# ADDENDUM No. 1

## RFP No. 23-59

### East Medical Center Drive Bridge Rehabilitation and Widening Project

SHEET NO. 80 OF 155

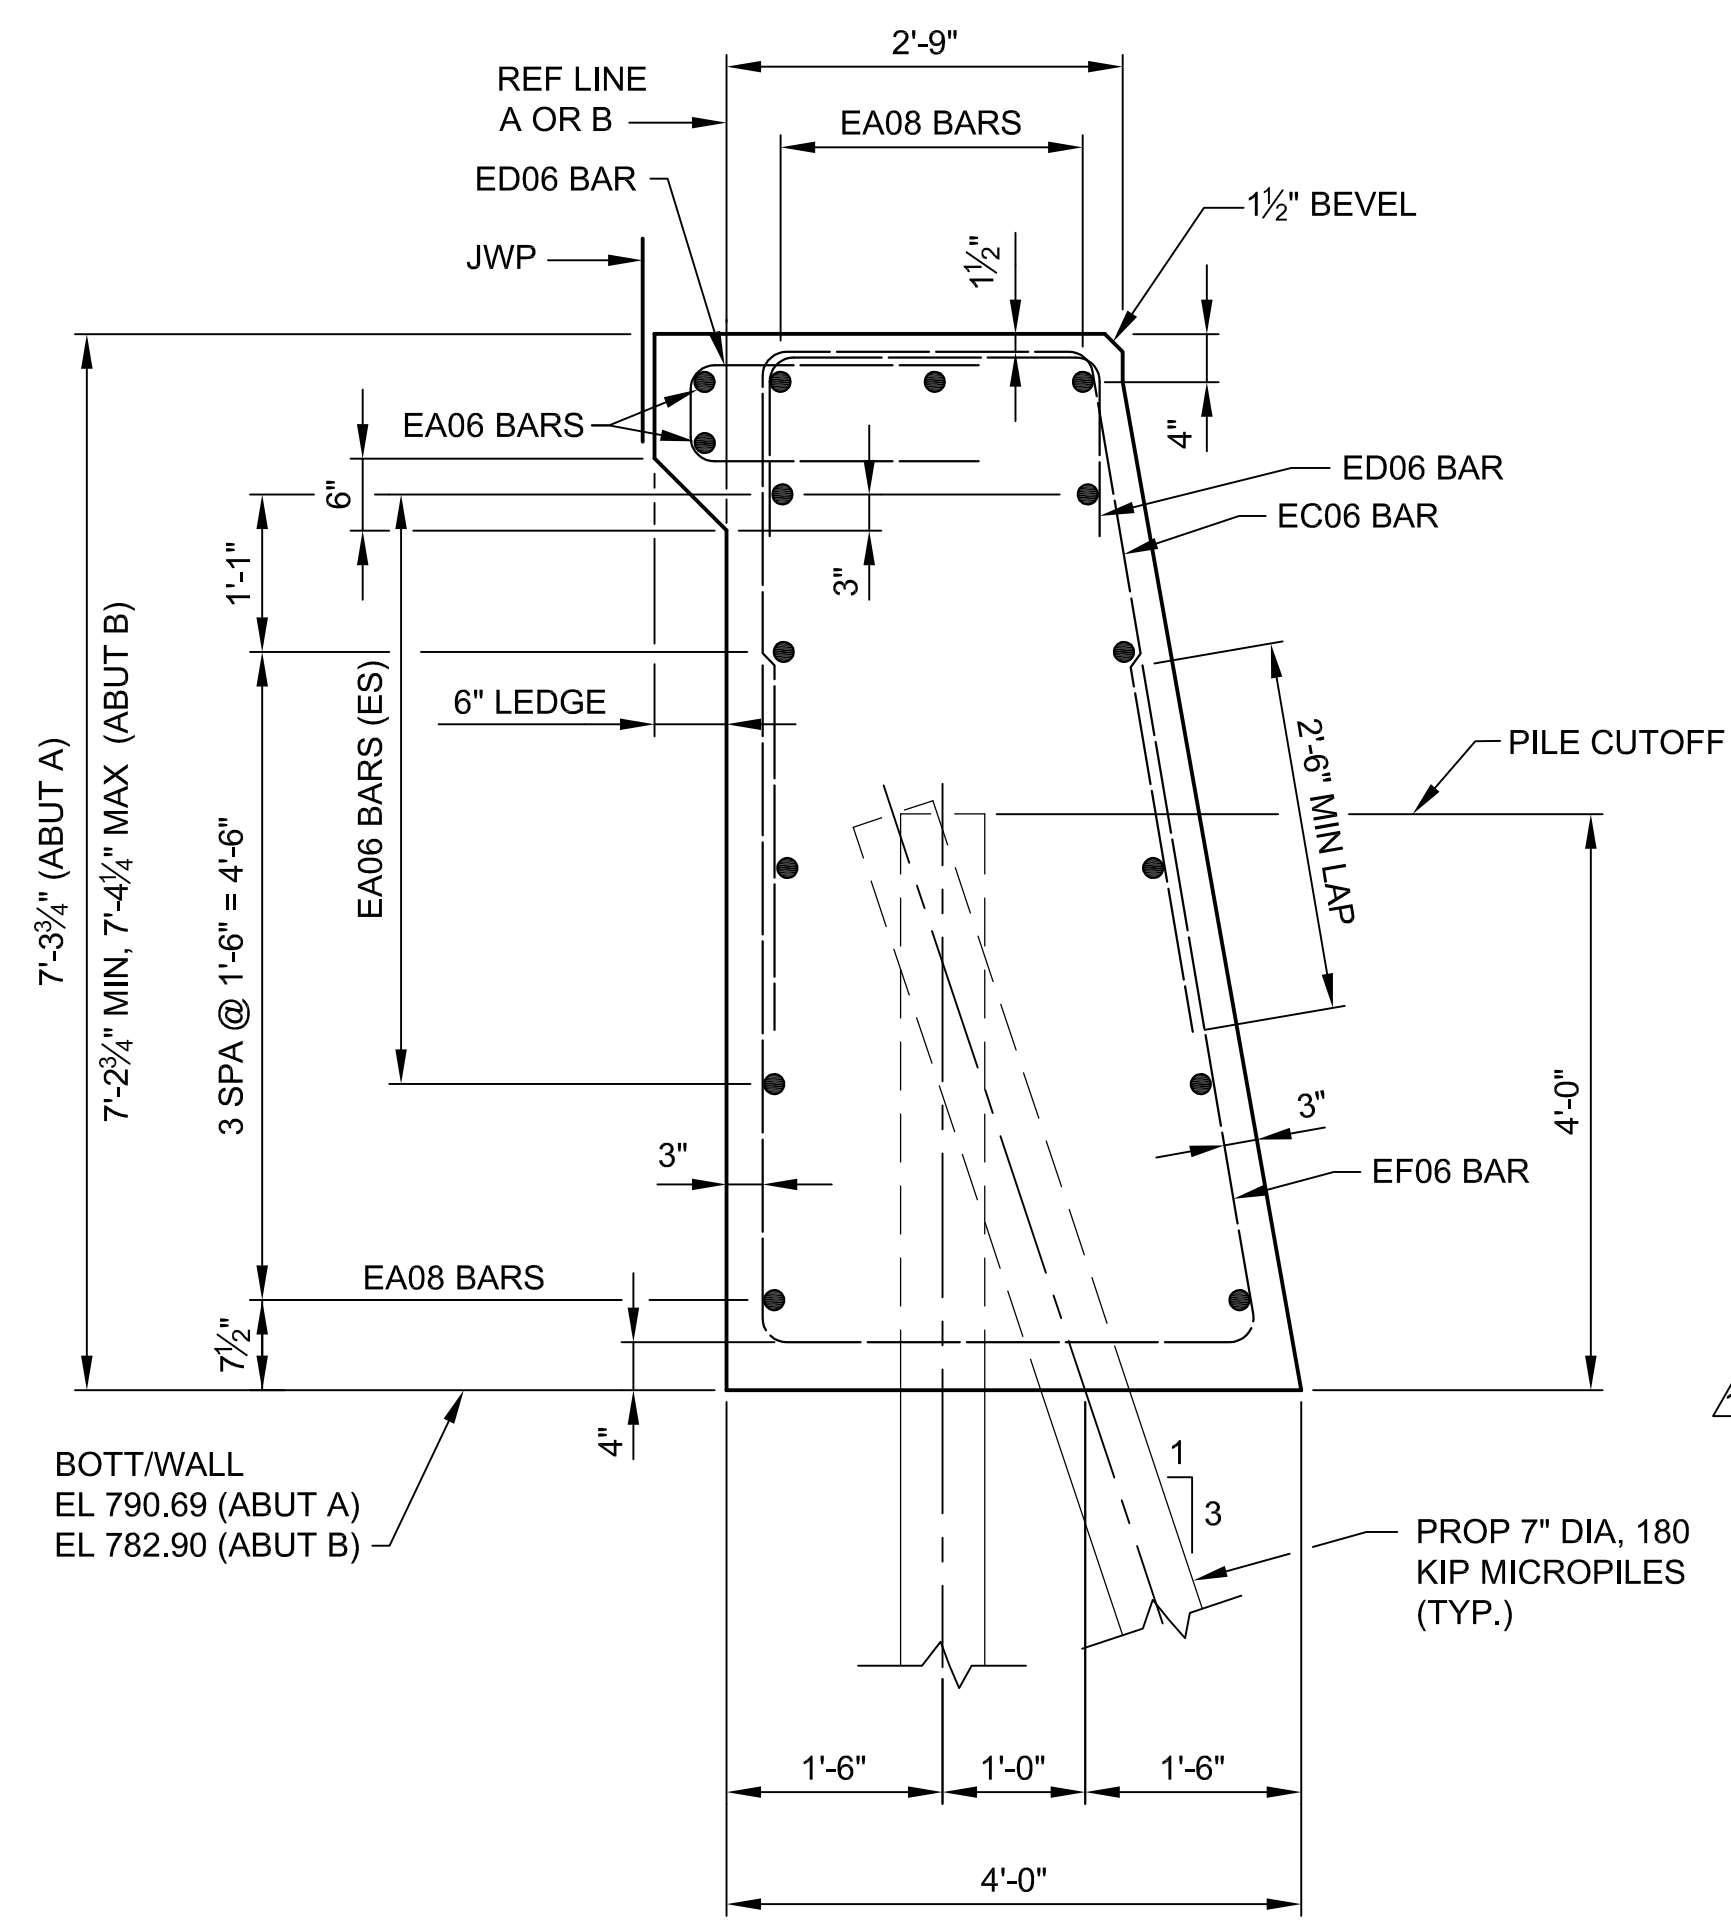
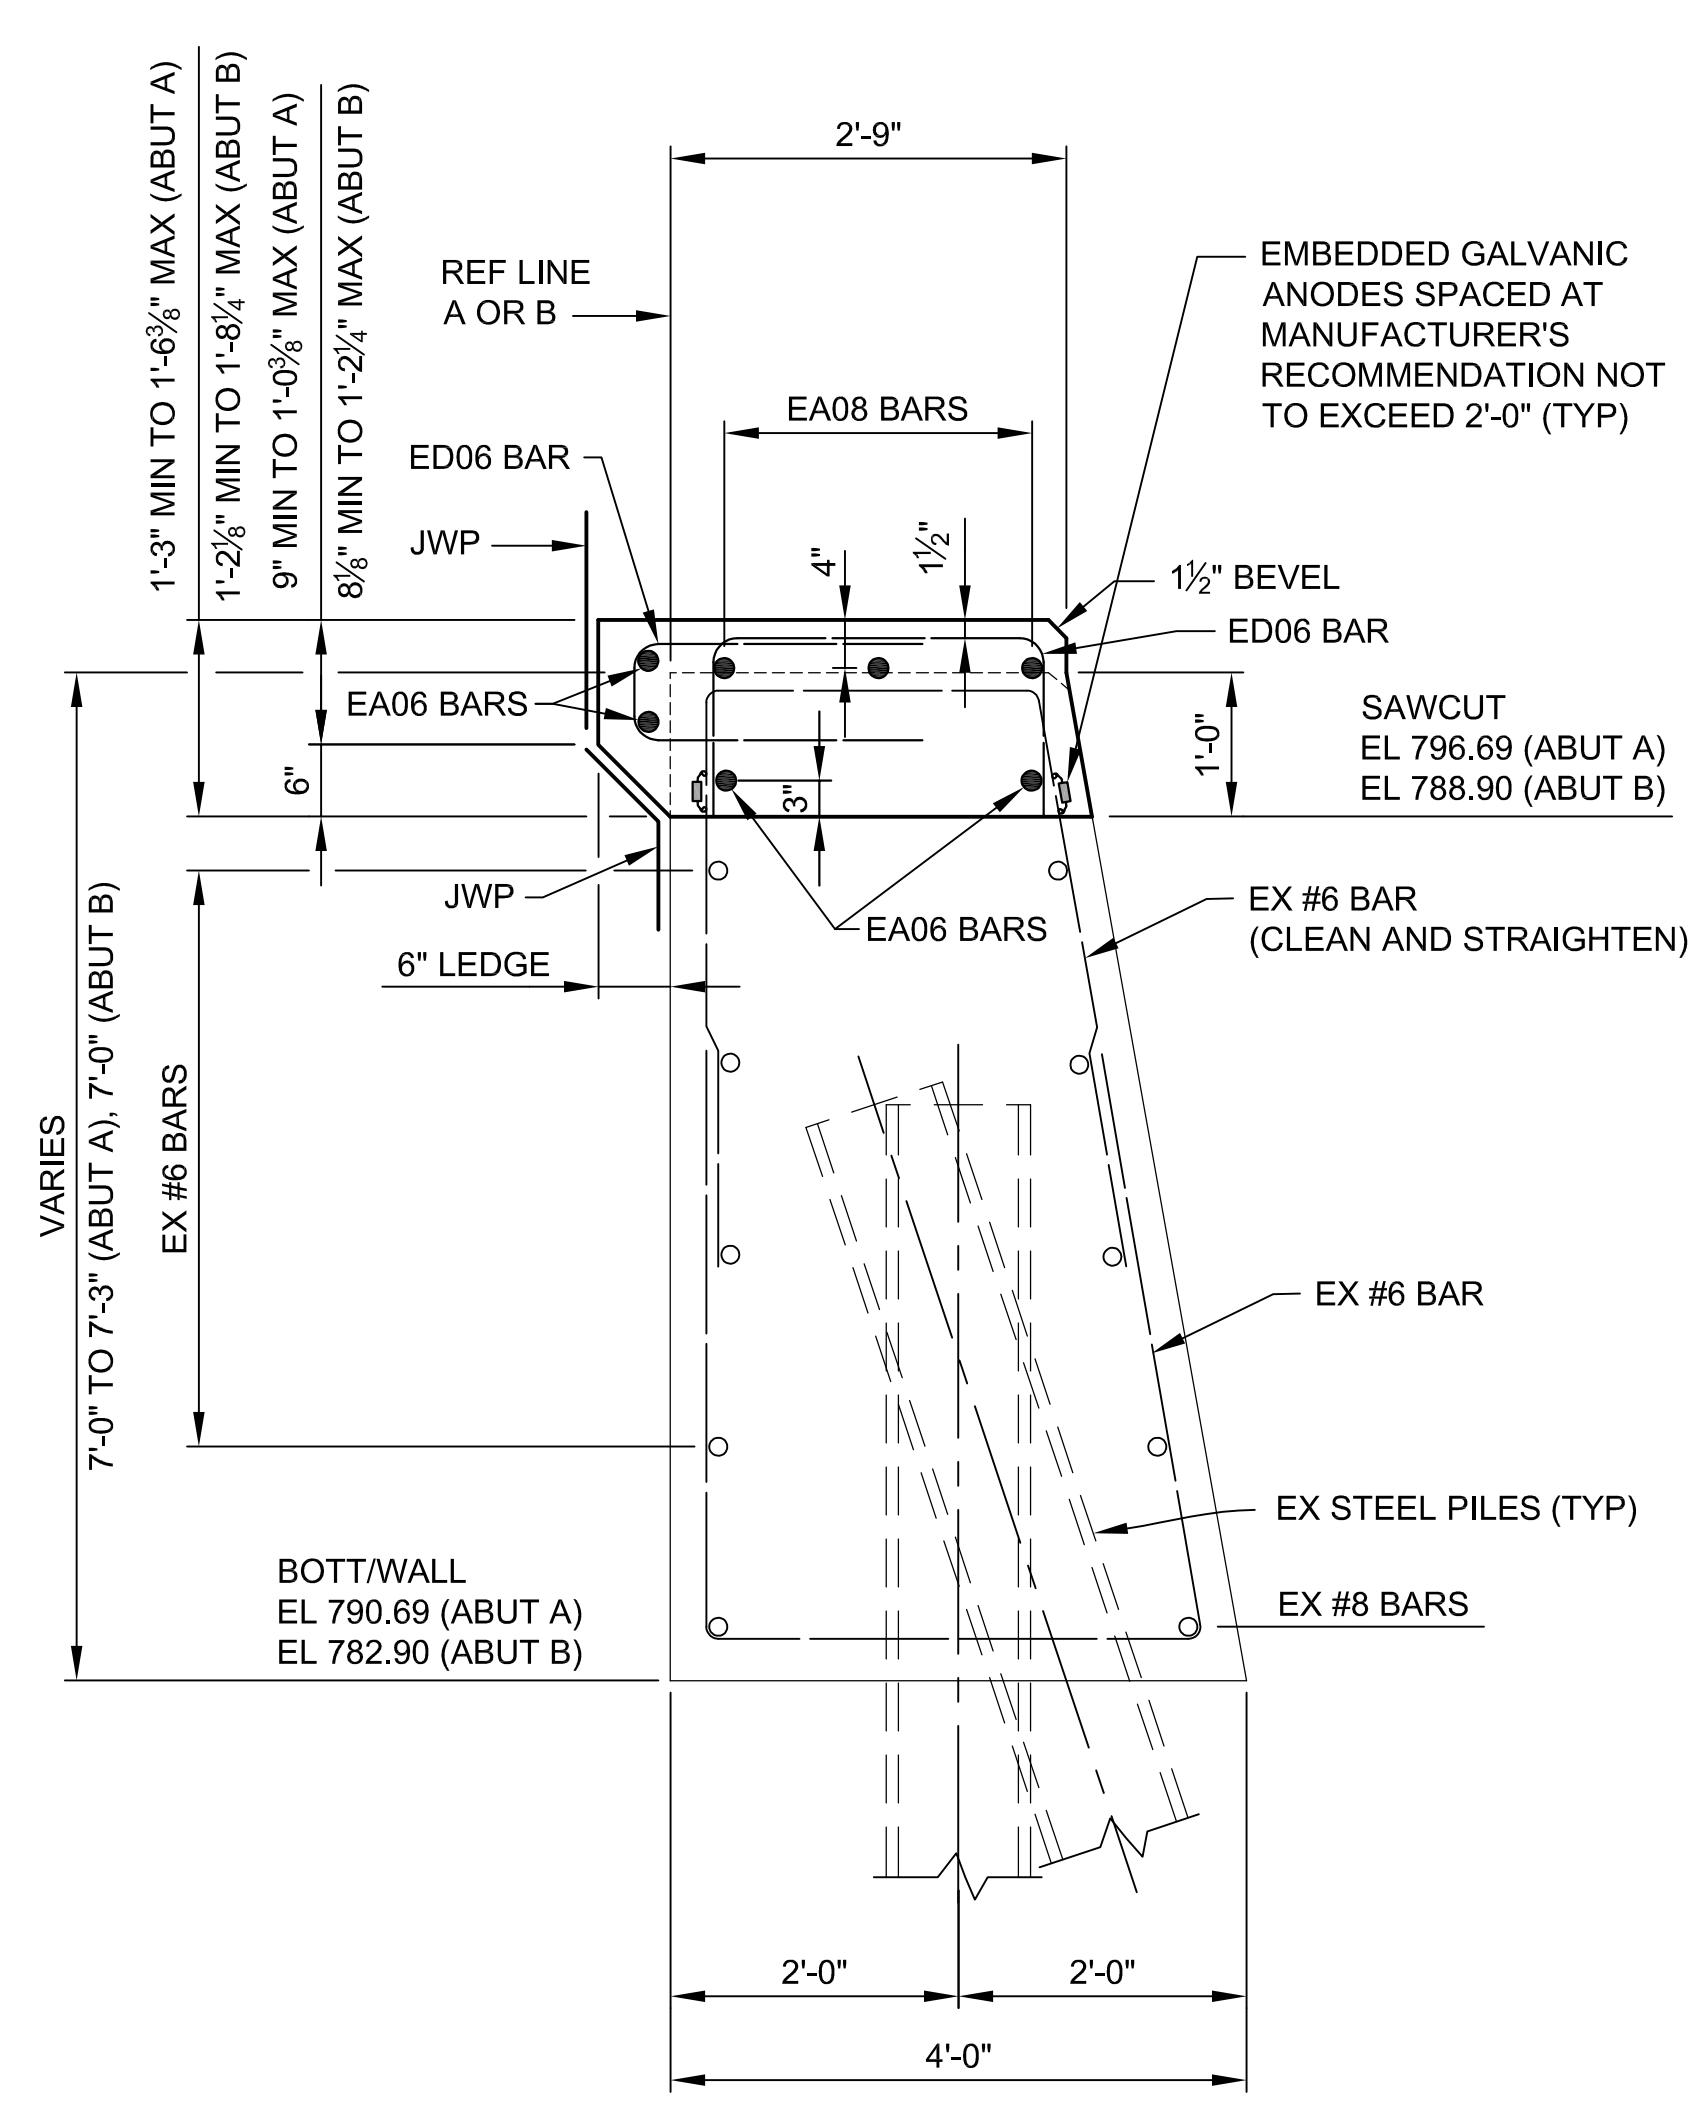
- Answer 7: The cost of the Track Inspector will be paid for by the City.
- Question 8: Drawing sheet 69 of 155 notes "Exist Permanent Steel Sheeting" at piers 1 and 2. The drawing infers that there is existing sheeting around the pier extension. The drawing shows "Steel Sheet Piling, Temp Left In Place" at the same location. Drawing 80 of 155 also details the 2 rows of sheeting. Please clarify.

- Answer 8: The drawing has been revised to show the existing sheeting only around the existing footing.
- Question 9: The drawing on sheet 69 shows 360 Sft of "Steel Sheet Piling, Temp" in the quantity table. Where is this item utilized in the plans?
